Site Plan Amendment, 82004026C, River Quarry Consent Amendment

Staff Report Revised: 03/13/12

Site Plan 82004026C: River Quarry Consent Amendment. Changes to the development program and to decorative site elements including lighting, driveways and walkways, paving, fences, and landscaping. Located at the intersection of River Quarry Place and River Road, Bethesda MD, at the north west quadrant of River Road and the Capital Beltway; R-200/TDR-12; 6.16 acres; Potomac Subregion.

Figure 4

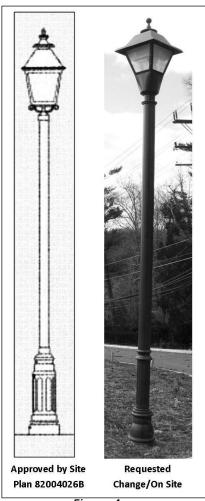
Staff does not feel the requested amendments to the site plan will change the community character or original intent of the approved Site Plan. Many of the changes, including the amendments to modify the entrance sign lighting, match the fence metal work with the gate, remove the second gate to lots 21 and 22, and install decorative pathway lighting will result in a more attractive overall design by removing visual clutter and enhancing the built environment around the proposed recreational areas. Likewise the proposed modifications to the stone pillars (figure 3), the streetlighting (figure 4) and the proposed pavers (figure 5) are minor and remain decorative and visually appealing.
